GJS Plot F, Manchester

Non-material Amendment | 25.09.2024

Z1-SHP-A180-RP-XX-NMA02 | P05

Consented Scheme - Z1-SHP-G100-PL-B2-B5D801 - P01

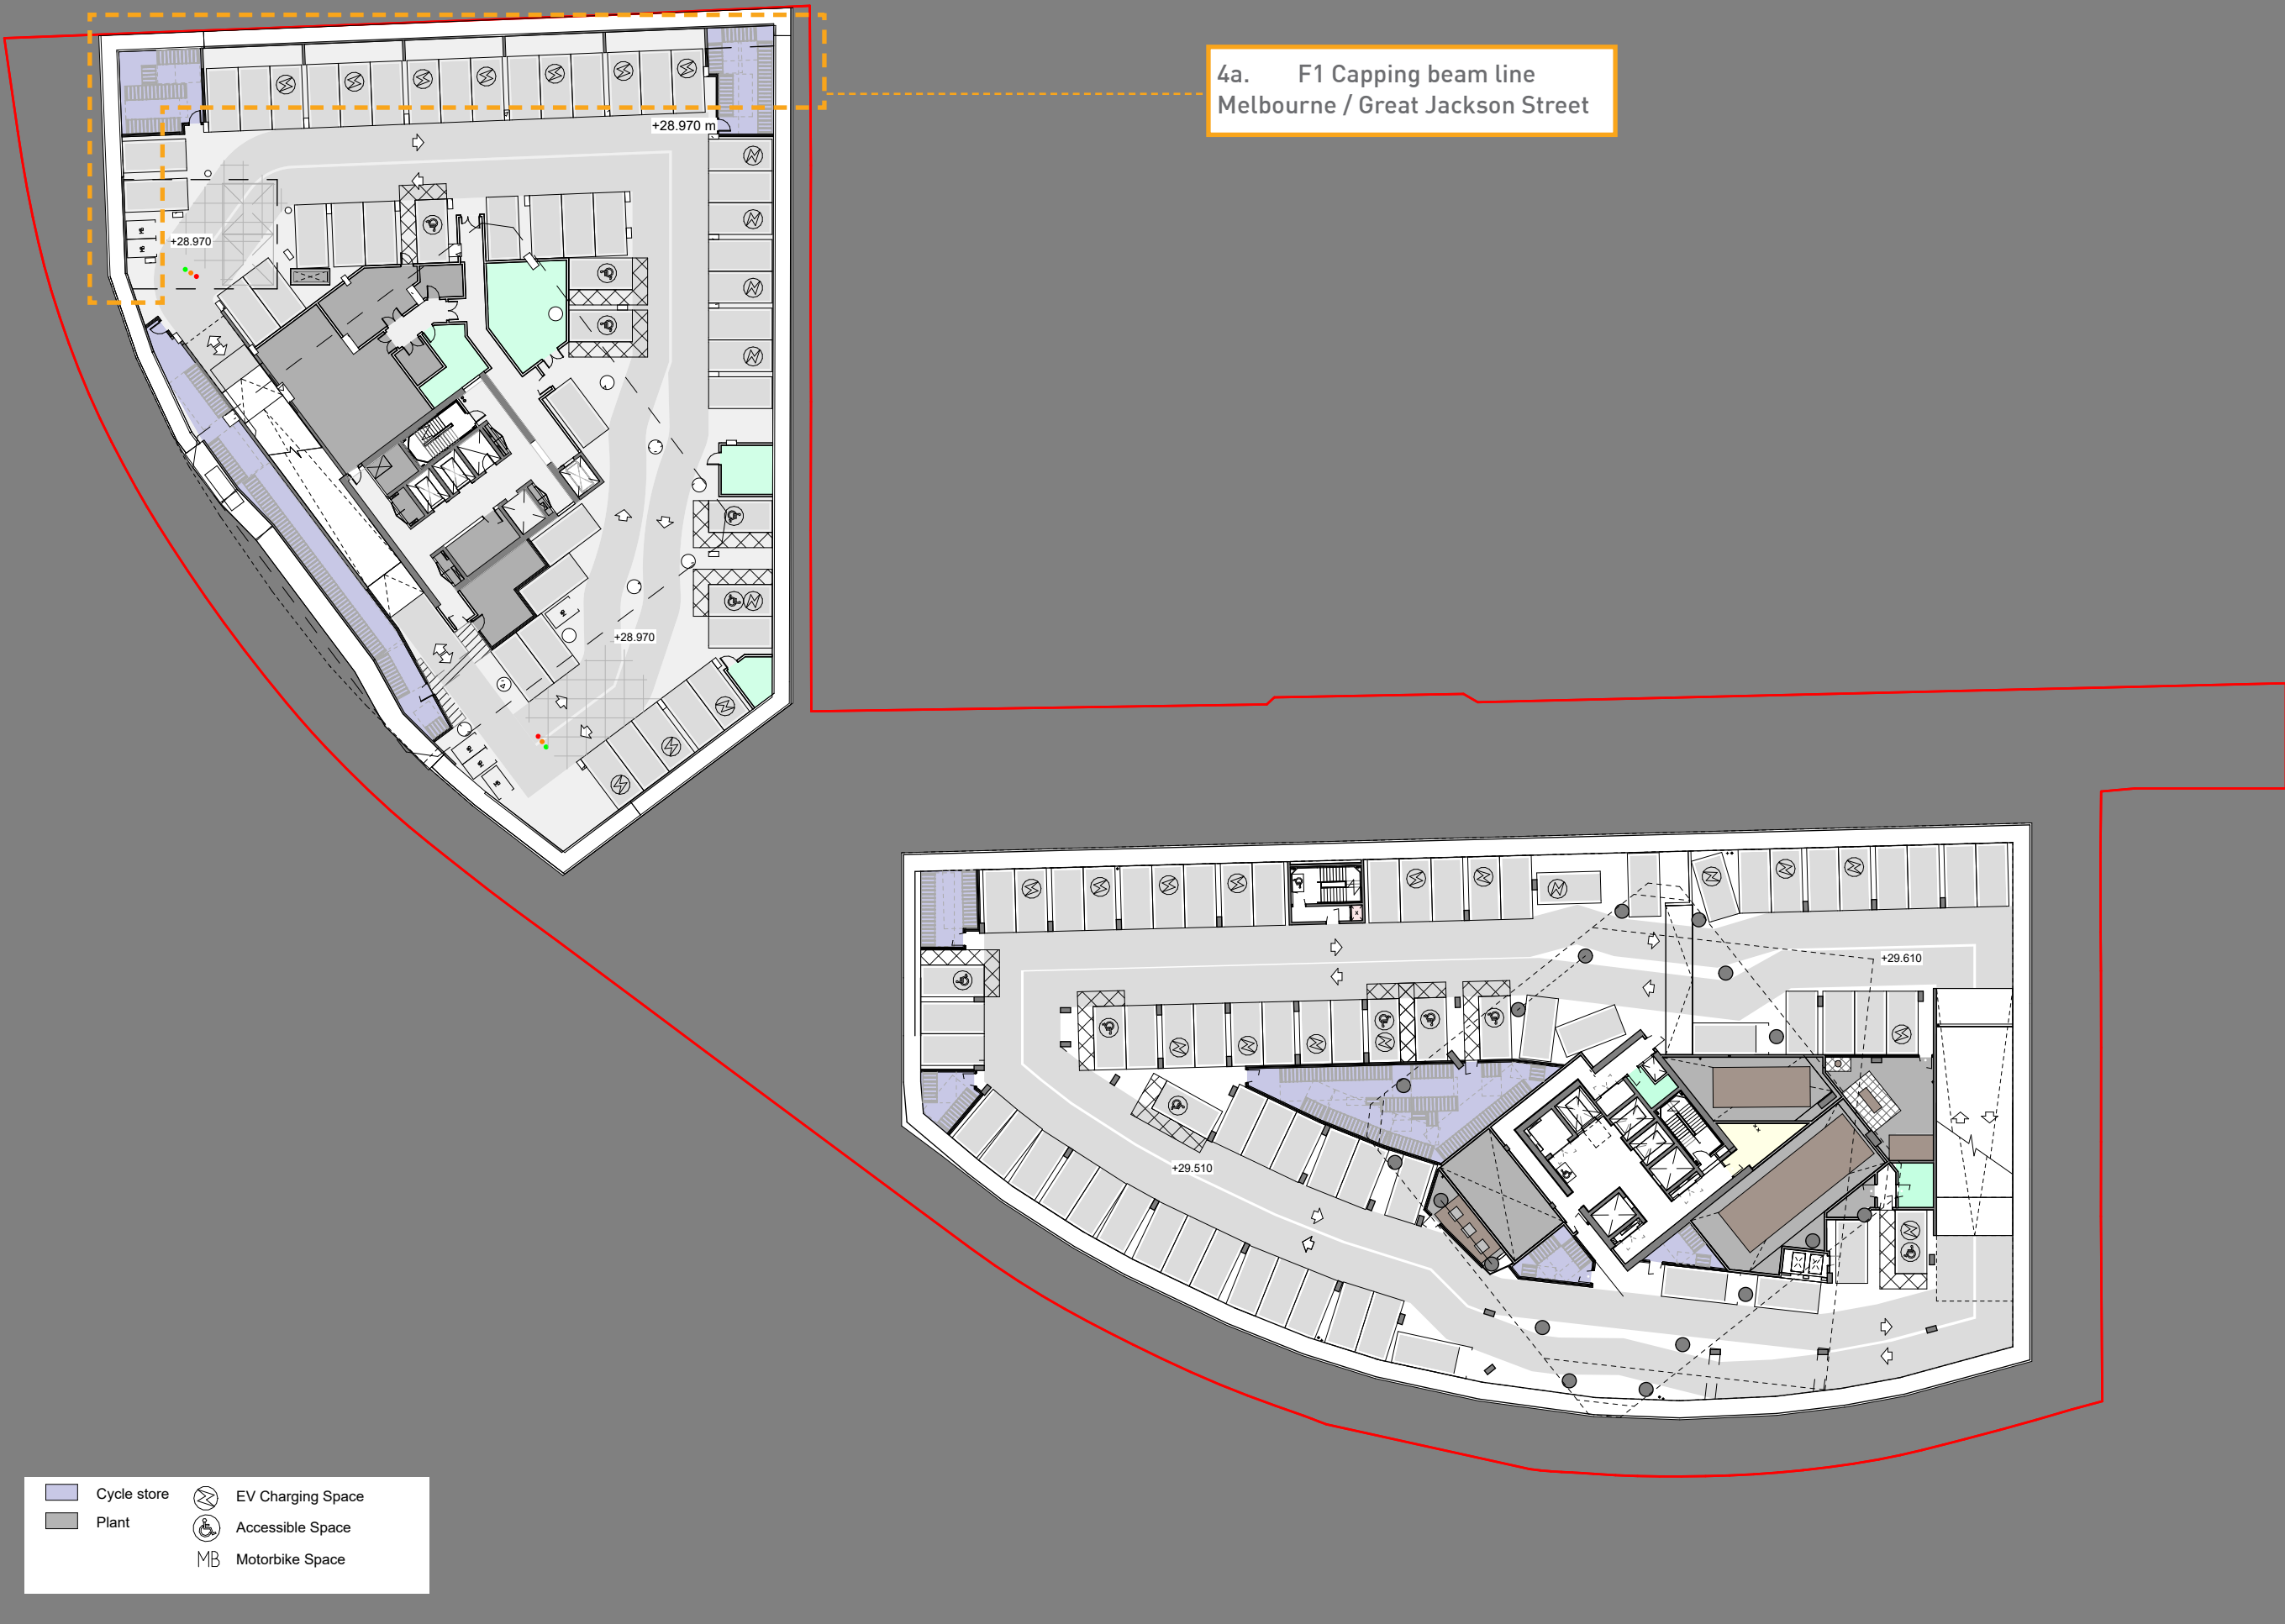
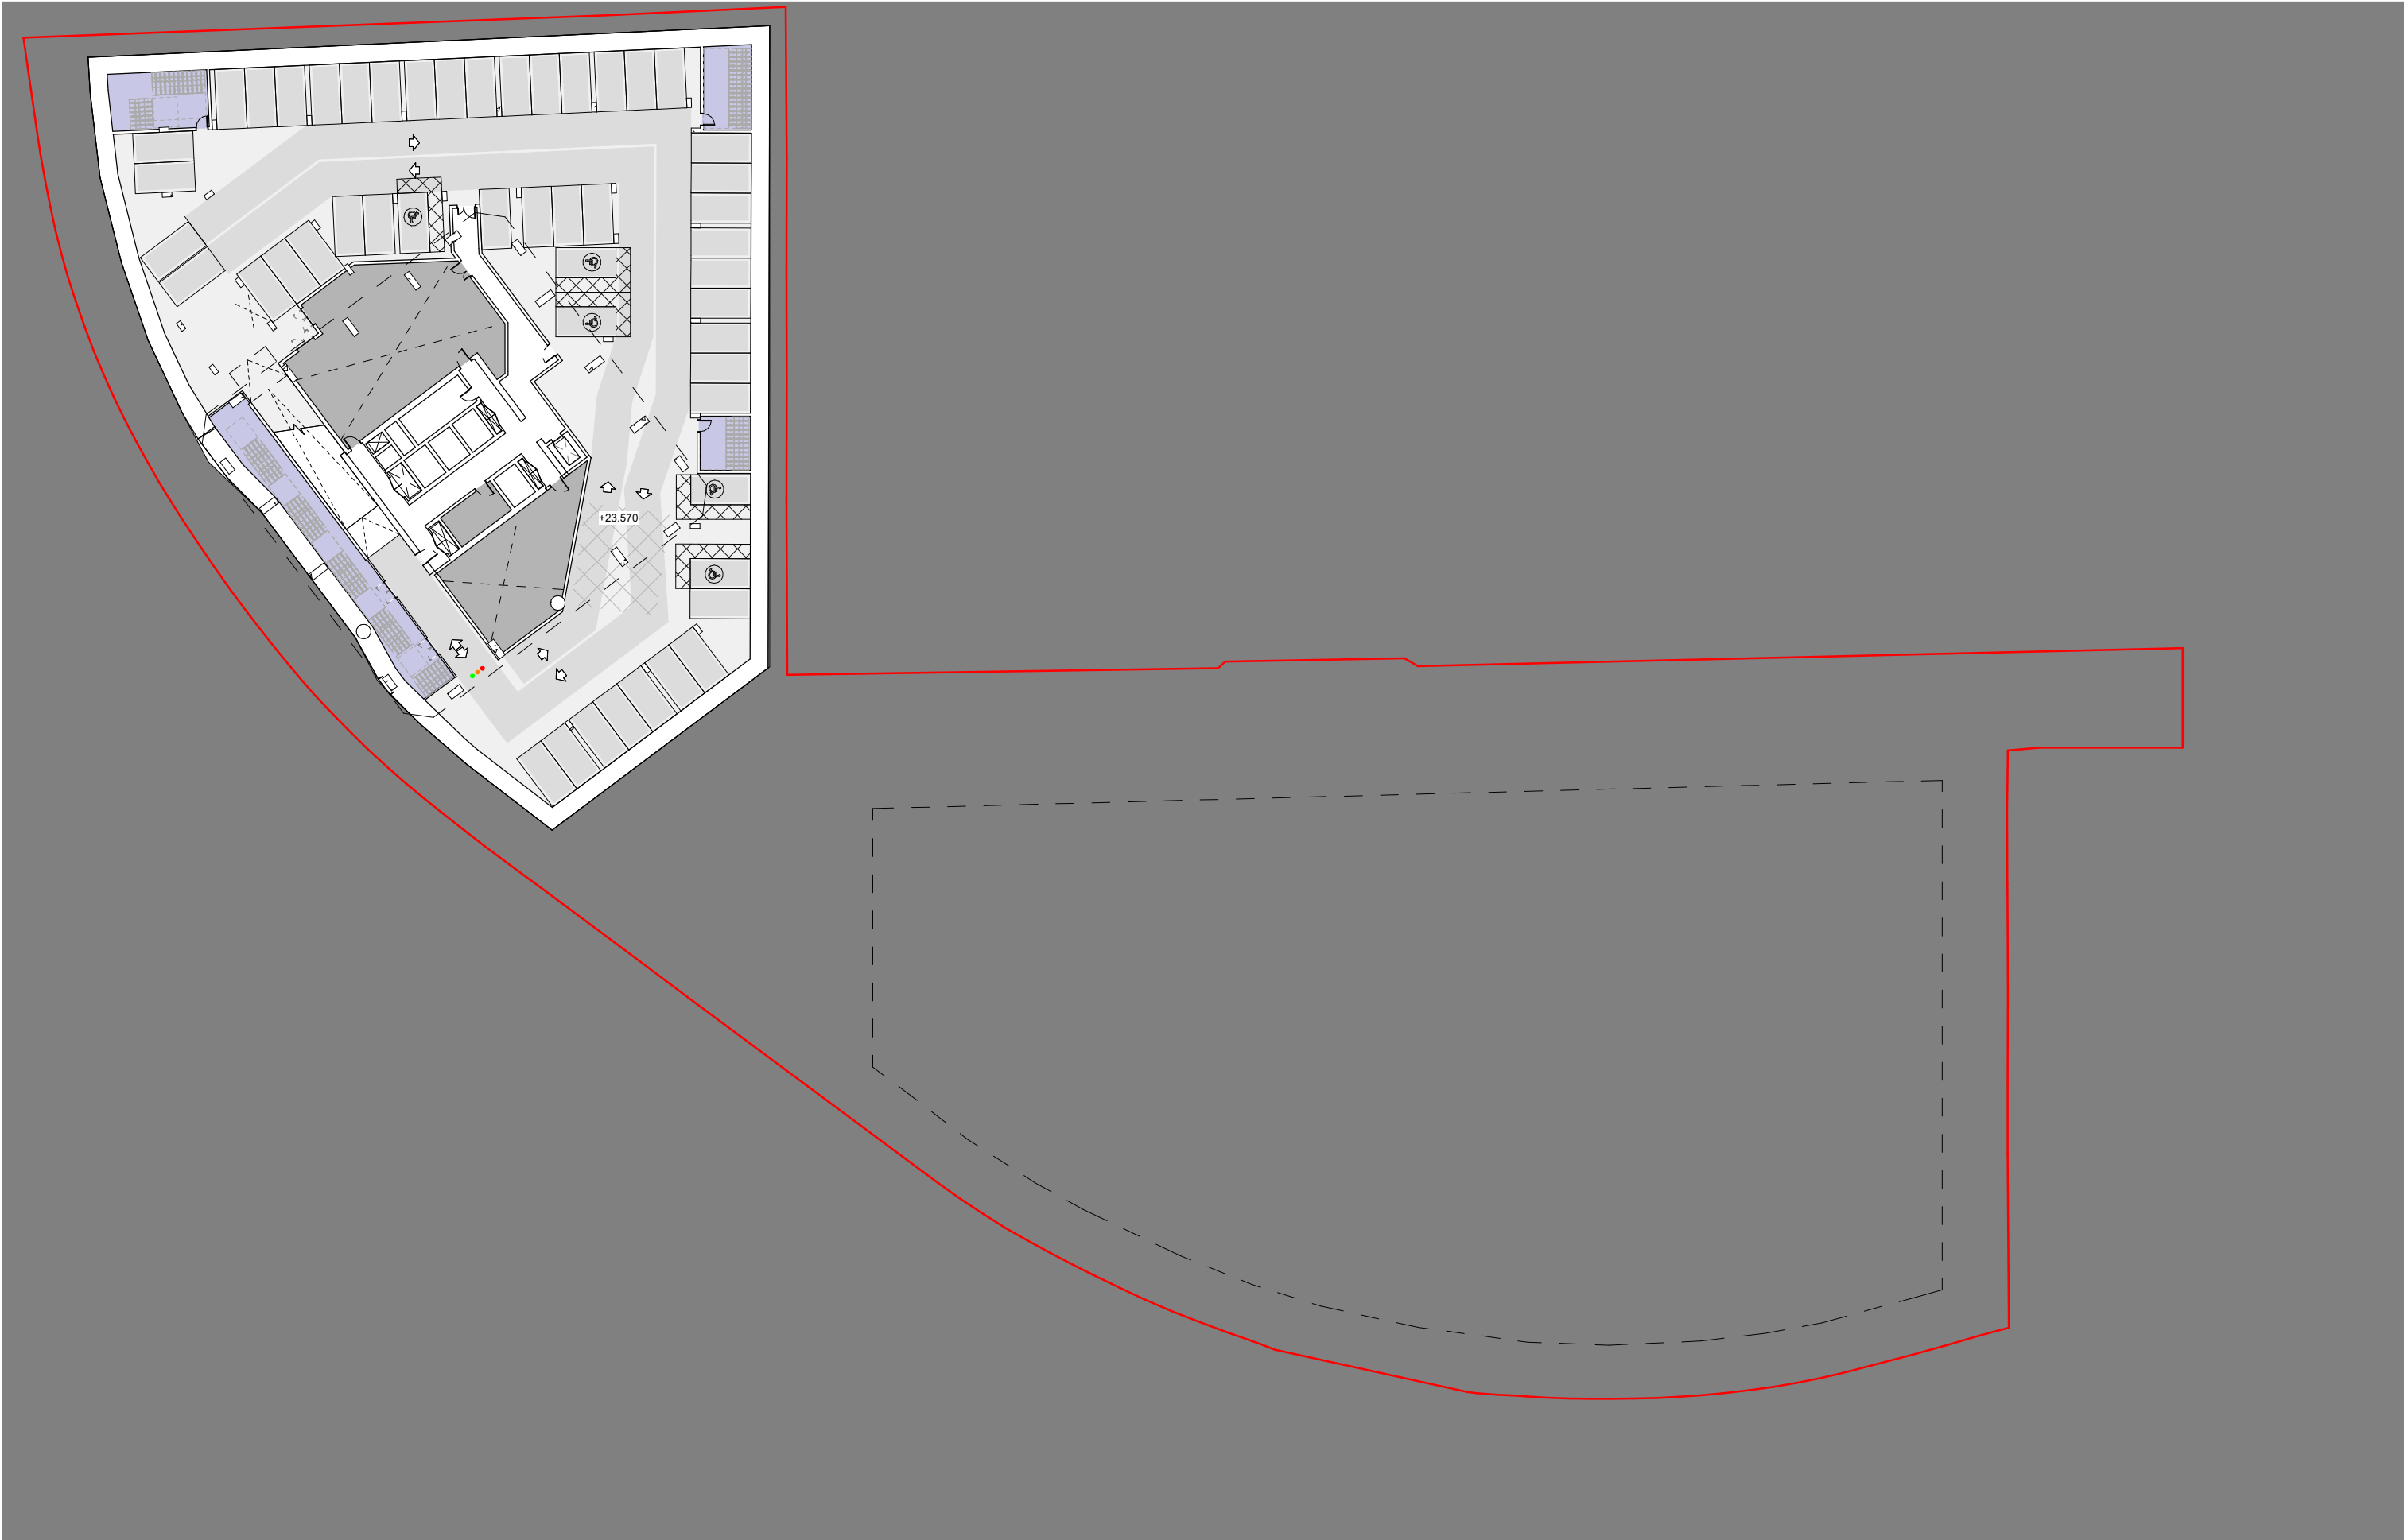
1.	Tower F1 - Removal of visible capping beam along Great Jackson Street At planning stage it was deemed neccessary to keep the capping beam (top of the basement piled wall) above ground level, due to the proximity of the F1 capping beam to the pavement. Through further structural design and refinement of temporary works, the design team have been able to lower the entirety of this structure so that it is not visible from street level, with the following benefits: <ul style="list-style-type: none">- Feature columns are able to run full height - are not interrupted by the capping beam structure.- The public realm between the development and the pavement is more successful allowing for a more natural pedestrian circulation around the building without this imposition.	4.	F1 Basement updates a. F1 Capping beam line Melbourne / Great Jackson Street The alignment of the capping beam for the F1 basement running down Melbourne Street has also been amended to tie in with the Crown Street Phase 3 application. The revised arrangement reflects the applicant’s updated land ownership and allows for construction efficiencies within the back to back basement design. Quantum of car parking, EVC and accessible provision remains as per consented.
